**Report: TAB Report
Function: Test, Adjust, & Balance
Date: 02/12/2026
Completed By: National TAB**

**PROJECT
02-09-26 QT #1061 ROCK HILL, SC**

**QUIKTRIP
4705 SOUTH 129TH EAST AVENUE
TULSA, OK 74134**

Project Issue Information

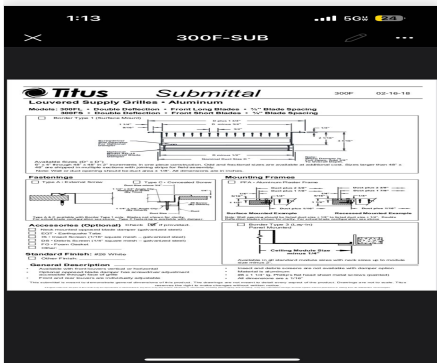
Issue Name : Unit final filters dirty
Description : All RTU final filters were dirty due to the dust and dirt from renovations. They were not dirty enough to effect balancing but will need to be replaced in the near future.
Created By : National TAB **Assigned To :** National TAB - Dan Hertenstein
Status : Open
Priority : Medium **Asset Tag :**
Originated Date : 02/12/2026 - Christian Moller - National TAB

Project Issue Information

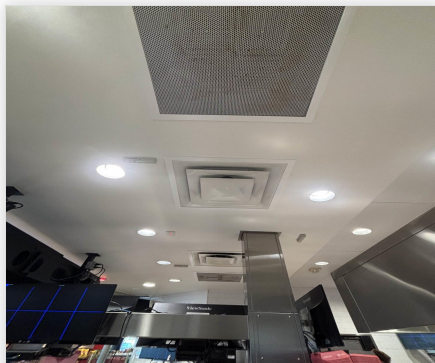
Issue Name : Wrong cook line diffusers
Description : The cook line diffusers are not the louvered supply grilles with adjustable deflection blades as per design. The ones installed now work fine as temporary grilles.
Created By : National TAB **Assigned To :** National TAB - Dan Hertenstein
Status : Open
Priority : High **Asset Tag :** RT-3
Originated Date : 02/12/2026 - Christian Moller - National TAB
